Staff Evaluation First Review

Application: Jeremy Broadhurst, Hyrum Self-Storage, Site Plan – Seeking recommendation to the City Council for site plan approval for self-storage located at 1746 East 175 South, and 225 South 1720 East.

Application Number: 26-013
Preparation Date: May 6, 2026
Applicant Name: Jeremy Broadhurst
Property Owner #1: Shipping Land LLC
Property Address: 1746 East 175 South
Parcel Number: 01-144-0019
Parcel Area: 0.98 Acres
Property Owner #2: Daniel Hurst
Property Address: 225 South 1720 East
Parcel Number: 01-144-0018
Parcel Area: 1.00 Acres

Site plan

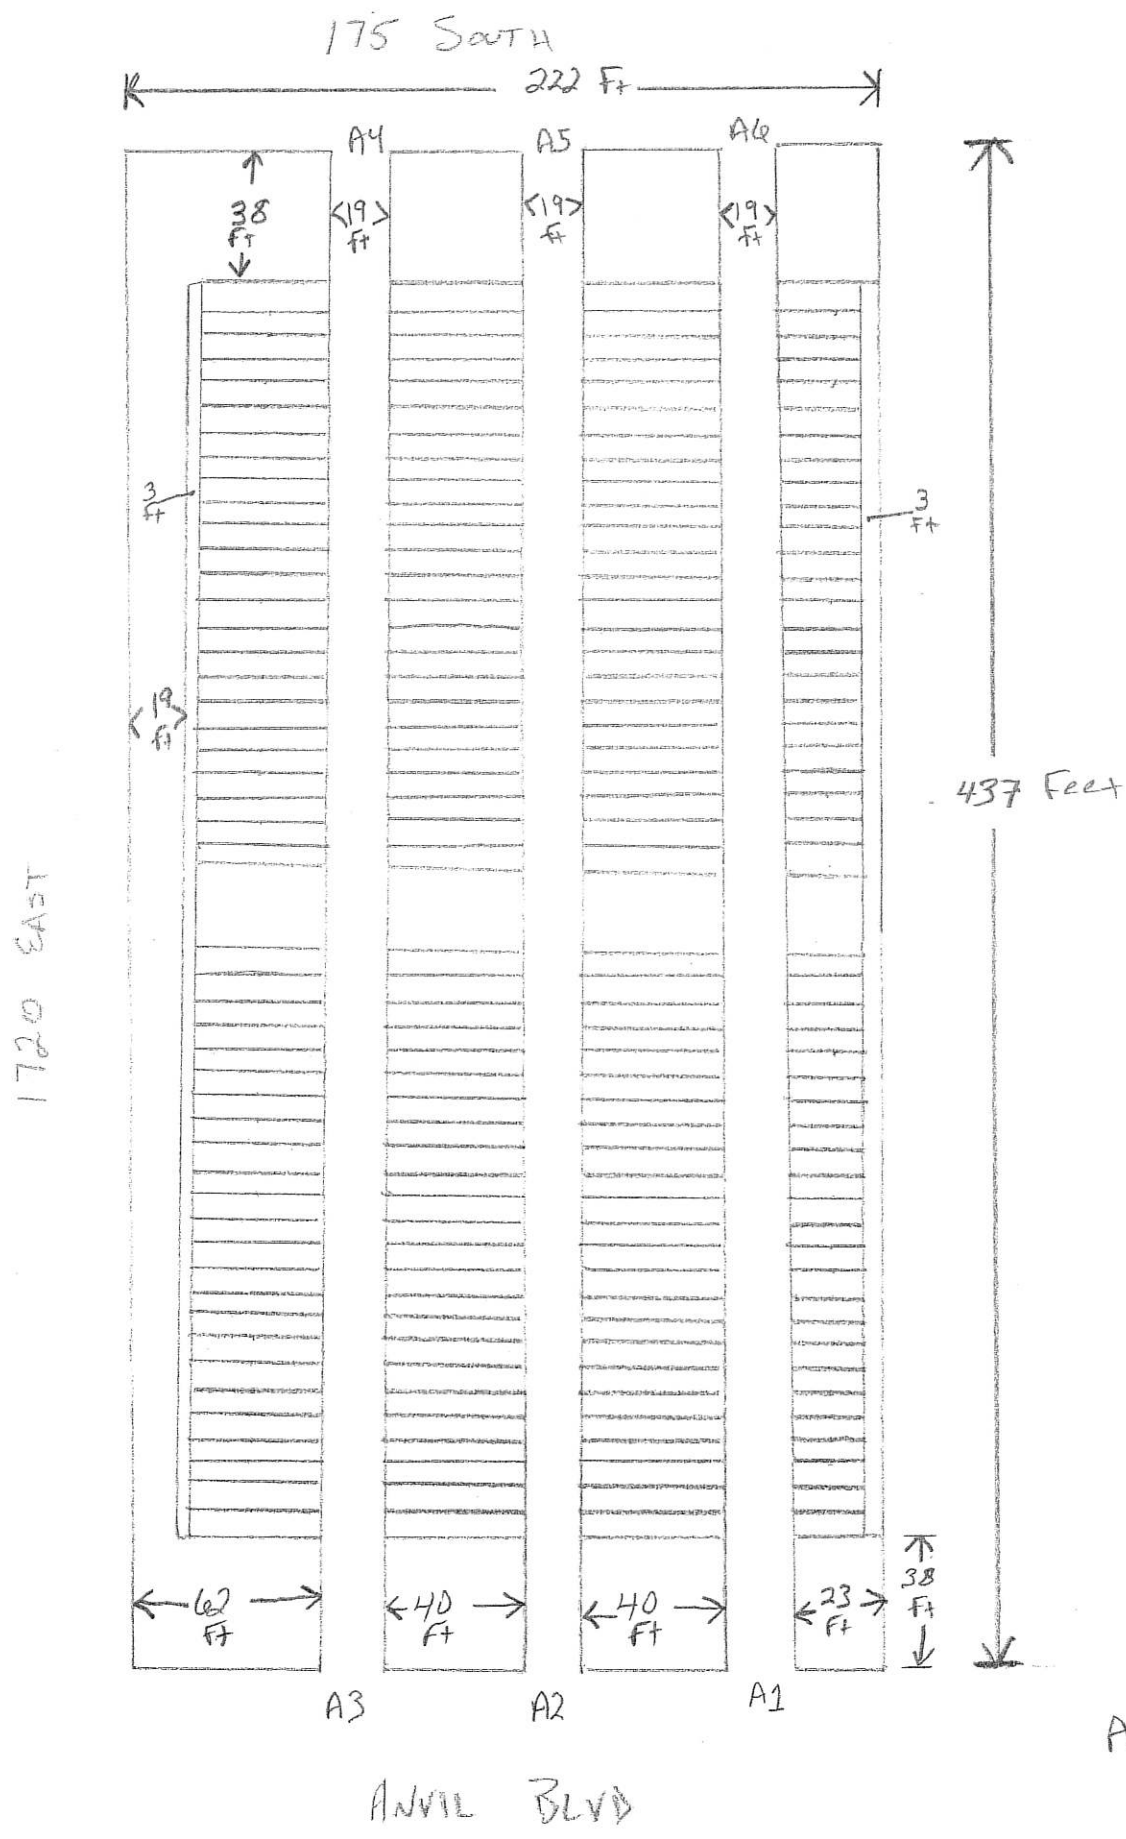
1. HCC 13.18.140: (storm water requirements will be a City Council discussion)
2. Stom water maintenance arrangements shall be implemented in accordance with this section which requires access to storm water detention, retention, and swale features for storm water management and access to inspect the storm water and to perform maintenance of the system. The proposed shipping containers bridged over the storm water do not comply with this requirement.

5. HCC 17.49.030: Refer to Comment Items #10, #11, #12 and #13. Buildings in the M-2 zone shall have a setback of thirty (30) feet from the front property line, unless otherwise specified by the Planning Commission prior to the erection of the building. There are two (2) platted properties that are proposing for the development. Each platted property has different addressed frontages abutting the roads which places the frontage requirements as shown in the exhibit below. HCC 17.49.150.B.1 also prohibits storage of any line from being located within required setbacks. Staff recommends the Planning Commission specify the applicant comply with the frontage requirements of this code section by either revising the site plan, change the address of property parcel 01-144-0018 to front Anvil Road, or combine the two (2) parcels. This code compliance will require a revised site plan.

7. HCC 17.49.030: Similar to Comment Item #4 and frontage requirements, the side and rear yards of each property parcel are not regulated to any setbacks other than meeting the landscaping requirements of HCC 17.49.150. The applicant does not demonstrate on the proposed site plan the property line separating the two (2) property parcels. There is no provision in this section of the code that will permit any building to cross the property line. The applicant will be required to resubmit a site plan demonstrating compliance with this section.

8. HCC 17.49.150.B.4: Storage units adjacent to any public roadway shall be single loaded with the back of the units facing the streets and doorways of the units facing inward toward other storage units. The applicant will need to indicate on a resubmitted site plan that the proposed development meets this code requirement.

9. HCC 17.49.150.B.3: All roadways and interior alleyways of any Self-storage facility is required by this section to provide either a concrete or asphalt surface. The applicant does not demonstrate in the proposed site plan the proposed surfacing. The applicant will be required to resubmit a site plan demonstrating conformance with the code section.

10. HCC 17.49.090: The site plan does not show dimensions for the proposed accesses for staff to verify compliance with this section that regulates not more than two (2) for each one hundred feet or fraction thereof of frontage on any street. The applicant will need to resubmit a site plan demonstrating the distances for each access to verify compliance with this section.

16. IFC 2021 503.2.1: The site plan access roads for the shipping containers do not meet the minimum fire apparatus access roads for maintaining a width of not less than 20 feet. HCC 17.08.100.C. requires the site plan shall contain the provisions required by the Fire Official Review. IFC 2021 503.2.4: The required turning radius of a fire apparatus access road shall be determined by the Fire Code Official which the Hyrum Fire Department is requiring a minimum turning radius of 28 feet. HCC 17.08.100.C. requires the site plan shall contain the provisions required by the Fire Official Review. To verify compliance with this section, the applicant will be required to update the site plan to a verifiable scale that includes the 13 feet wide park strip and curb and gutter and identify the minimum turning radius of 28 feet. The applicant may use the street cross section of the Blacksmith Fork Industrial Park Public Improvements-Construction Drawings for reference purposes to complete this requirement:

20. HCC 17.04.070: The applicants first submittal did not include a reference to the drawing scale, and the property dimension are not correct (i.e., applicant provided the north and east boundary as 222 feet x 437 feet; the north and east boundary is recorded as 198.70 feet x 412.99 feet on the Final Plat). Staff recommends the applicant obtain a copy of the recorded Final Plat at the Cache County Recorder's office for the correct boundary lines for the properties. The applicant will be required to provide a to-scale drawing and drawing scale reference of the proposed development with correct property boundary dimensions and show how the applicant determines to resolve Comment Item #5.

- a. This includes the design of retention/detention facilities. SCS method must be used.
3. It is recommended the city require further details as to how the developer will support the shipping containers over the ponds. Shipping containers are not structurally designed to “bridge” an open space with supports on each end. Further information should be required to identify how the structures will be supported to bridge the ponds and prevent rusting

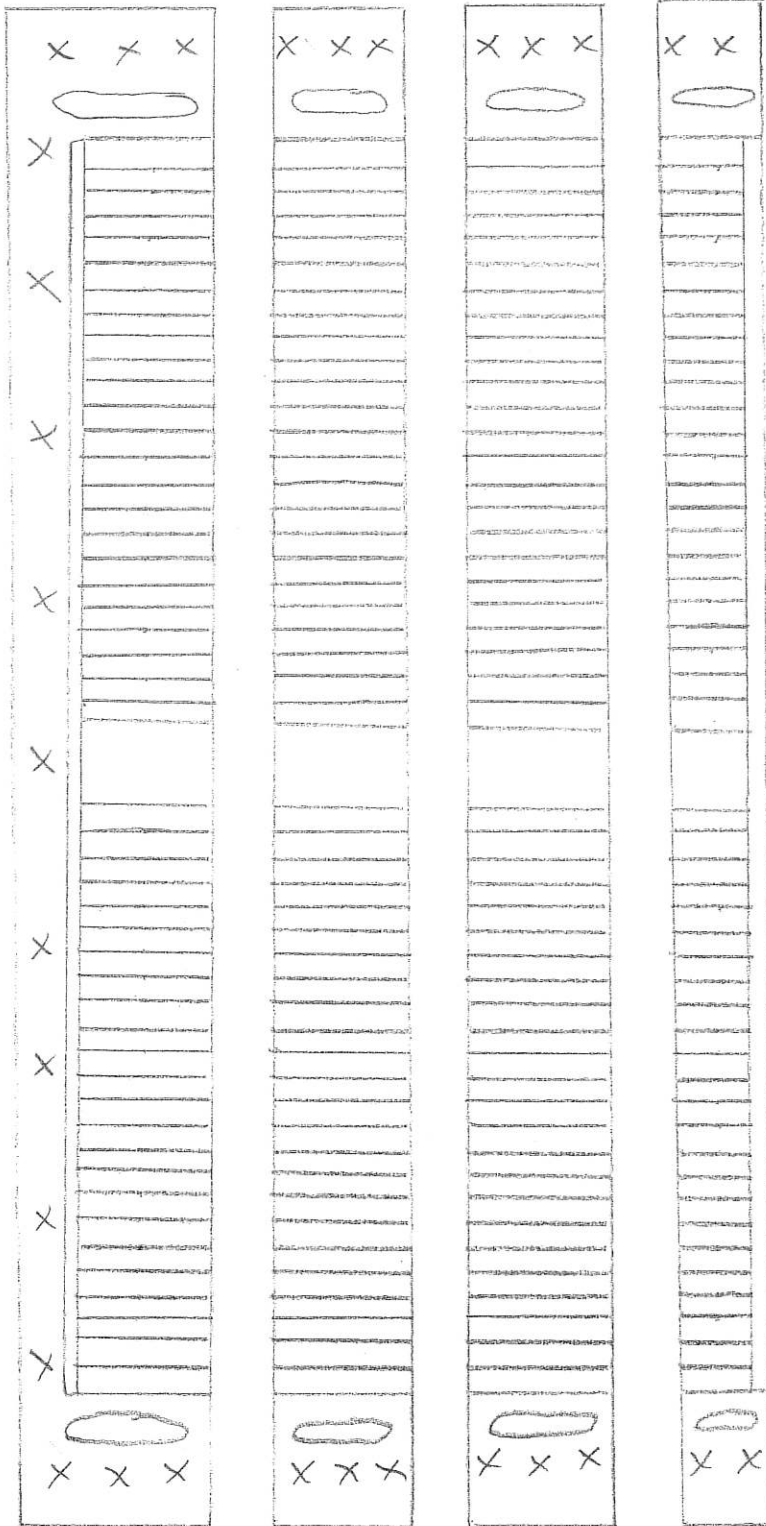
11. HCC 17.49.150.B.7: All setbacks are required to be irrigated by an automatic sprinkler irrigation system, and the landscape plan notes the irrigation will be provided by culinary water. The landscape plan will be required to include an approved backflow prevention device by the Public Works Department that complies with HCC 13.08.100.

12. HCC 17.49.150.B.5: Refer to Comment Items #4 and #13. Front yard setbacks shall be landscaped and screened with a combination of deciduous and coniferous trees and shrubs to cause at least a 50% screen within 5 years. Trees must be planted at 2-1/2" caliper while shrubs must be planted with at least 5 gallon nursery stock. The applicant shall resubmit a landscape plan demonstrating compliance with this section.

13. HCC 17.49.150.B.6: Refer to Comment Items #4 and #13. All side yard and rear yard setbacks shall be landscaped and screened with a combination of deciduous and coniferous trees and shrubs to cause at least a 25% screen within 5 years. Trees must be planted at 1-1/2" caliper while shrubs must be planted with at least 1 gallon nursery stock. The applicant shall resubmit a landscape plan demonstrating compliance with this section.

14. HCC 17.49.150.B.8: The developer shall landscape and grade the street facing frontage using one of the following options or other approved screening as approved by the City. Staff will not support any screening deviation than Option A or B. The applicant shall include on the resubmitted site plan and landscaping plan which Storage Bay Standard Option A or B is selected and provide the corresponding Option A or Option B detail on the plans to meet this requirement. The 25 feet required setback shall begin at the property line as required by this section.

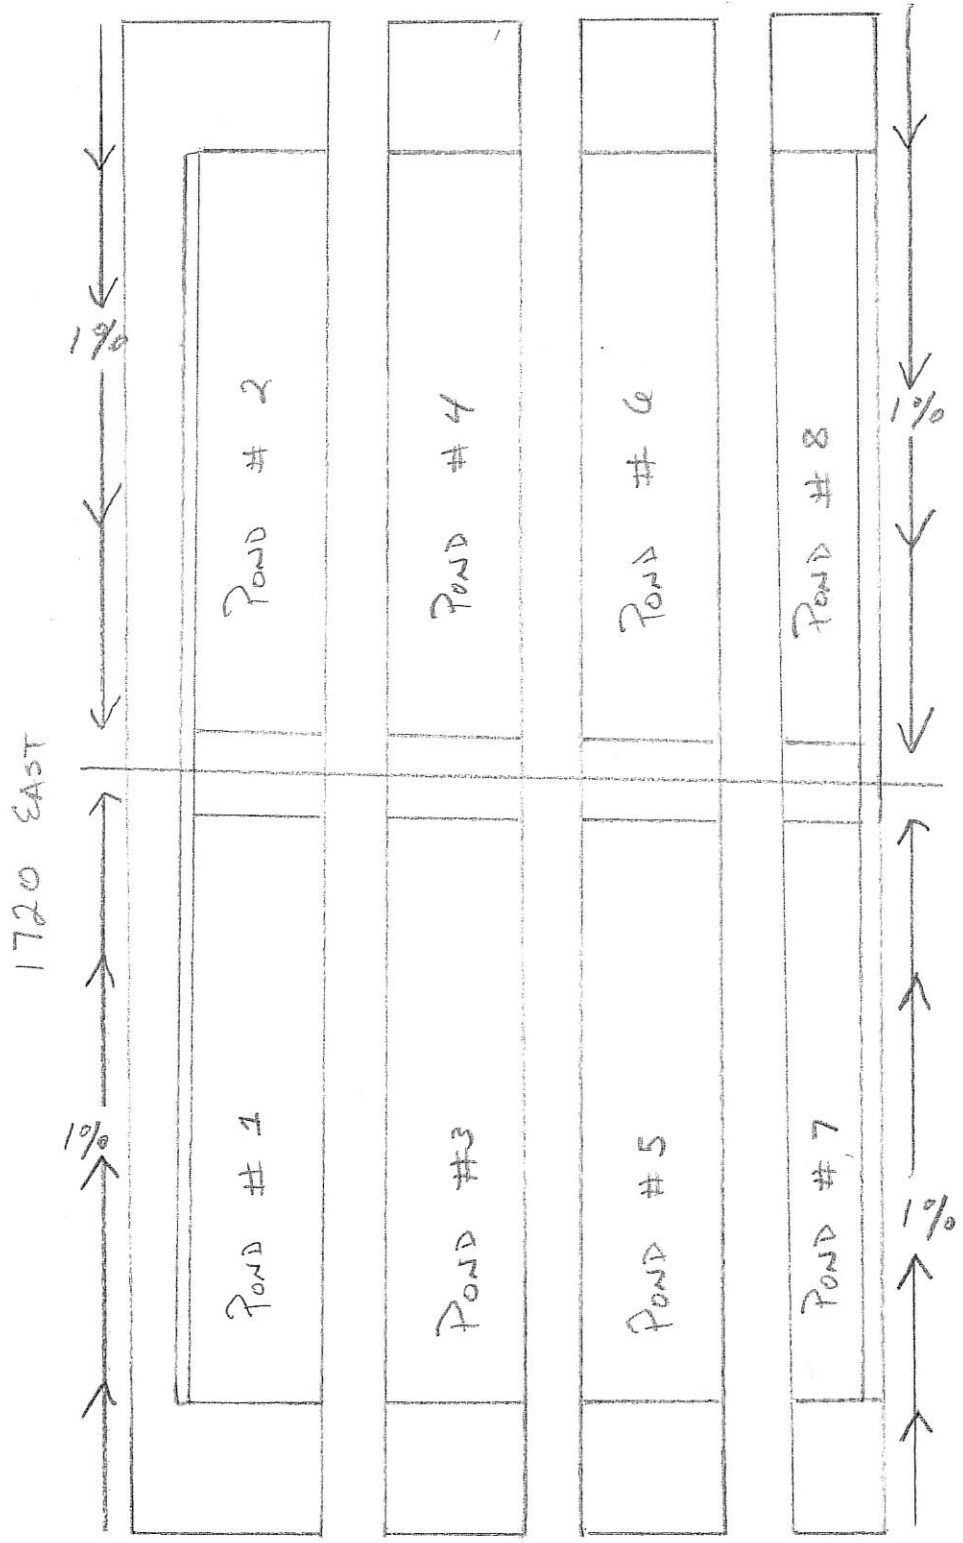
1. The current submission does not include piping, catch basins, pond overflows, and other aspects of a storm water system required for the system to operate fully. A complete review cannot be performed without Engineered plans outlining the entire system. We recommend the city require a full design prior to acceptance of the site plan.
2. Below are two items directly from the Cache County Storm Water Standards that should be considered by the design engineer based on the proposed pond design.

- i. Registration with the DWQ and a Class 5 Injection Well Permit are required for all underground retention/infiltration systems.
- j. The design, as proposed, references the NOAA ATLAS 100 year event. The design storm outlined in the Cache County Storm Water Standards should be used.

C.1 – “The rational equation is not allowed for design of best management practices.”
